## ATTACHMENT A

## ATTACHMENT B

### Moorebank Precinct West Stage 2

## Moorebank Precinct East Stage 2

#### MPW Stage 2 indicative phasing plan (SSD-7709)

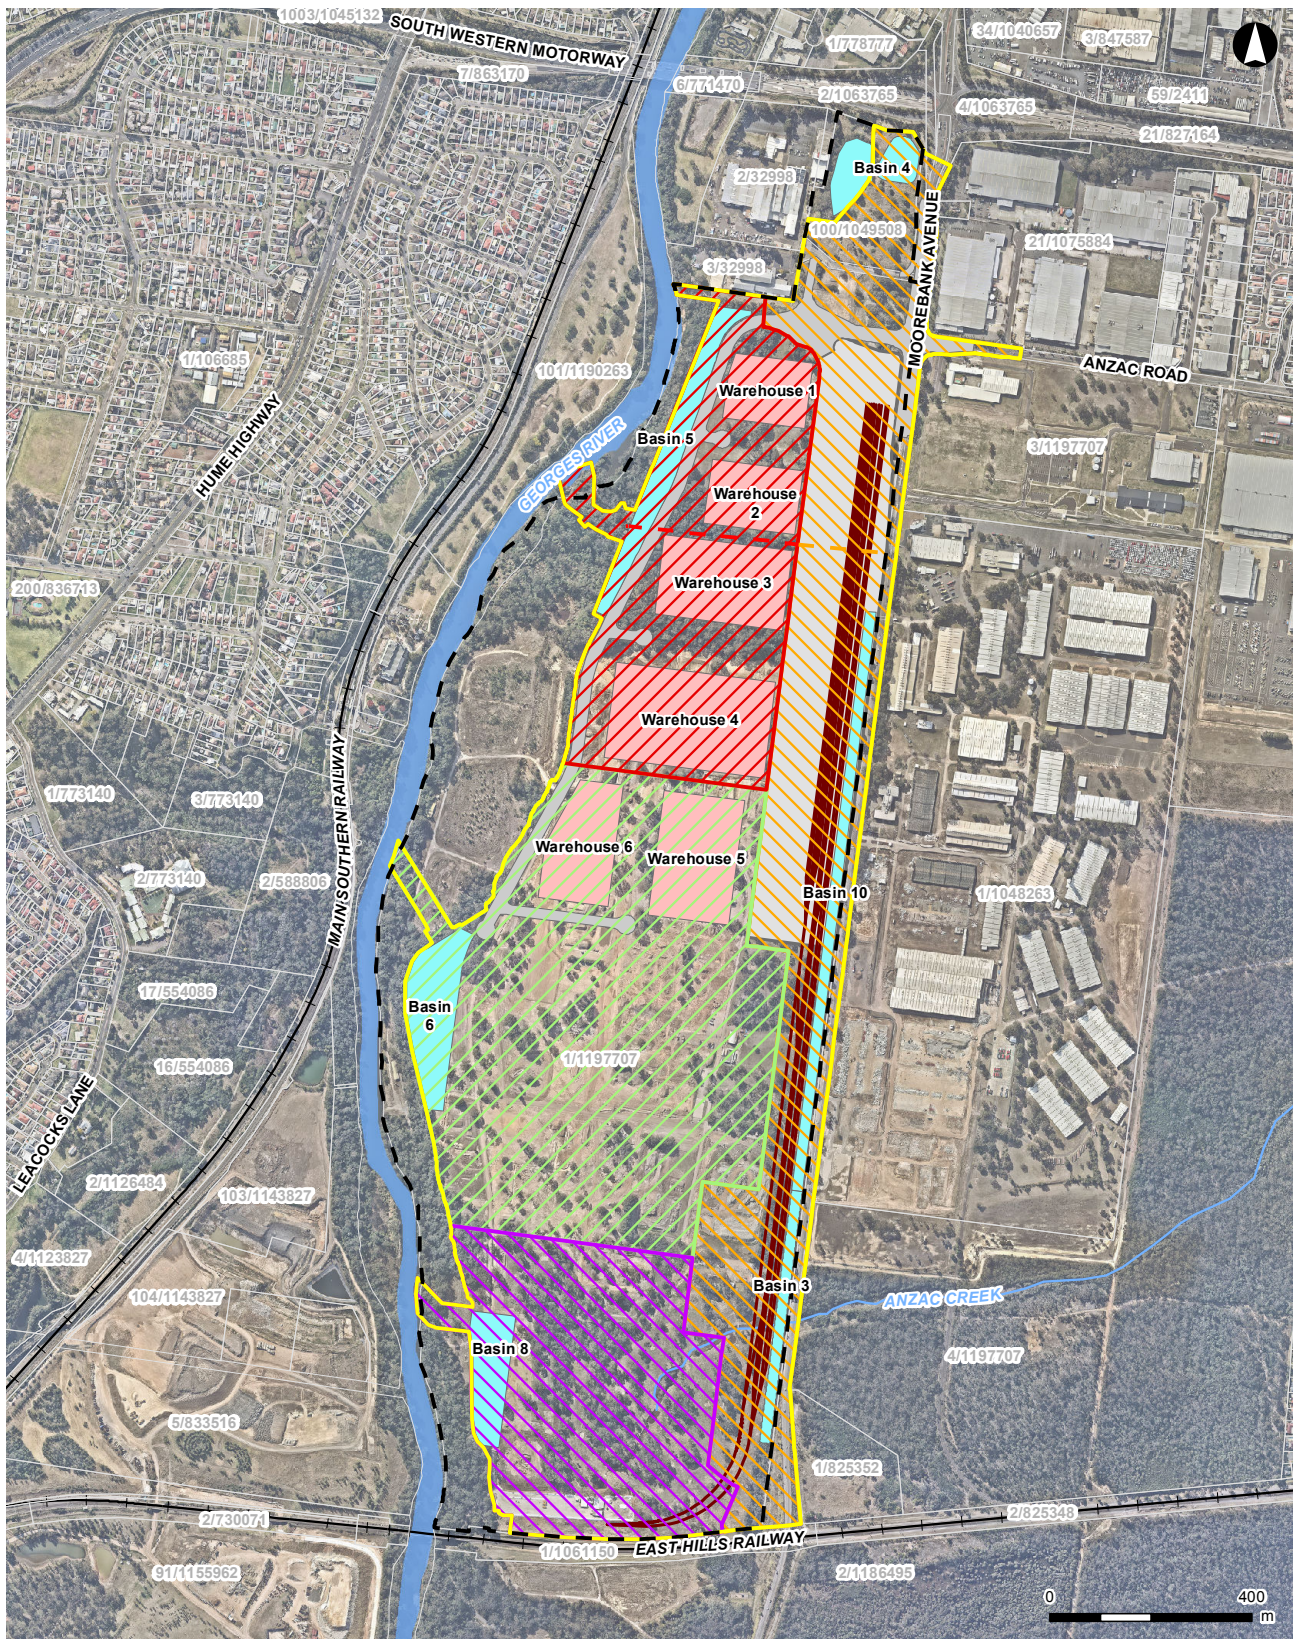
Aspect	Issue	Response	Reference
		<p>As the works to be undertaken in phase 0 are for the purpose of facilitating construction of the permanent built operational infrastructure, would be across the entire site footprint and are largely enabling works, these are not included in the phasing below; however, for completeness have been shown in the matrices provided at Attachment B of this letter to detail how this phase of works would align with the works periods included in the MPW Stage 2 and MPE Stage 2 consolidated project descriptions.</p> <p><u>MPE Stage 2</u></p> <ul style="list-style-type: none"> <li>Phase 1: construction works relating to the Moorebank Avenue upgrade, basin 10 part of basin 1, warehouses 1, 3, 4 and 5, internal roads and drainage channels. More detailed indicative staging specific to the Moorebank Avenue Upgrade within this phase of construction of the MPE Stage 2 Proposal has been provided to DP&amp;E previously as Attachment C of the <i>'Response to Transport for NSW Submissions on Moorebank Precinct West (MPW) Stage 2 (SSD 7099), MPW Concept Plan Mod 1 (SSD 5066_MOD 1), Moorebank Precinct East (MPE) Stage 2 (SSD 16_7628) and MPE Concept Plan Mod 2 (MP 10_0193 MOD 2)'</i> letter, issued to DP&amp;E from SIMTA on 29 August 2017.</li> <li>Phase 2: construction works relating to warehouses 6, 7 and 8, basin 2, internal roads and drainage channels.</li> <li>Phase 3: construction works relating to warehouse 2, part of basin 1, basin 2, and the northern internal access road.</li> </ul> <p><u>MPW Stage 2</u></p> <ul style="list-style-type: none"> <li>Phase 1: construction works relating to the Moorebank Avenue/ Anzac Road intersection upgrade, basin 3, basin 4 and basin 10, truck emergency parking north of the main entry,, upgrade to part of the east-west drainage channel (including the works immediately north of basin 10), intermodal terminal and rail access. More detailed indicative staging specific to the Moorebank Avenue/ Anzac Road intersection upgrade within this stage of construction of the MPW Stage 2 Proposal has been provided to DP&amp;E previously as Attachment D of the <i>'Response to Transport for NSW Submissions on Moorebank Precinct West (MPW) Stage 2 (SSD 7099), MPW Concept Plan Mod 1 (SSD 5066_MOD 1), Moorebank Precinct East (MPE) Stage 2 (SSD 16_7628) and MPE Concept Plan Mod 2 (MP 10_0193 MOD 2)'</i> letter, issued to DP&amp;E from SIMTA on 29 August 2017.</li> <li>Phase 2: construction works relating to the remainder of the east-west drainage channel upgrade, warehousing, basin 5 and internal roadworks.</li> <li>Phase 3: construction works relating to warehousing, basin 6 and internal roadworks.</li> </ul>

Phase	Phase Description	Works period A – Pre-construction stockpiling	Works period B – Site Preparation Activities	Works period C – Bulk earthworks, drainage and utilities	Works period D – Moorebank Avenue intersection works and internal road network	Works period E – IMT facility and Rail link connection construction	Works period F – Construction and fit-out of warehousing and freight village	Works period G – Miscellaneous structural construction and finishing works
0	<ul style="list-style-type: none"> <li>Pre-construction activities, including: establishment of temporary erosion and sediment controls, minor clearing and grubbing of temporary stockpiling area, establishment of a temporary stockpiling pad and associated temporary access roads, installation of temporary construction compound, including amenities and office for bulk earthworks and the importation and placement of approximately 400,000 cubic metres (m³) of clean fill.</li> <li>Site preparation activities, including: establishment of construction compound fencing and hoardings, installation of temporary sediment and erosion control measures, vegetation clearance, installation of temporary site offices and amenities, construction of hardstands for staff parking and laydown areas, establishment of temporary batch plant sites and installation of batch plant, construction of access roads, site entry and exit points and security, set up of construction monitoring equipment</li> </ul>	✓	✓	x	x	x	x	x

1	Construction works relating to the Moorebank Avenue/ Anzac Road intersection upgrade, basin 3, basin 4 and basin 10, truck emergency parking north of the main entry,, upgrade to part of the east-west drainage channel (including the works immediately north of basin 10), intermodal terminal and rail access.	x	x	✓	✓	✓	✓	✓
2	Construction works relating to the remainder of the east-west drainage channel upgrade, warehousing, basin 5 and internal roadworks.	x	x	✓	x	x	✓	✓
3	Construction works relating to warehousing, basin 6 and internal roadworks	x	x	✓	x	x	✓	✓
4	Construction works relating to warehousing and basin 8.	x	x	✓	x	x	✓	✓
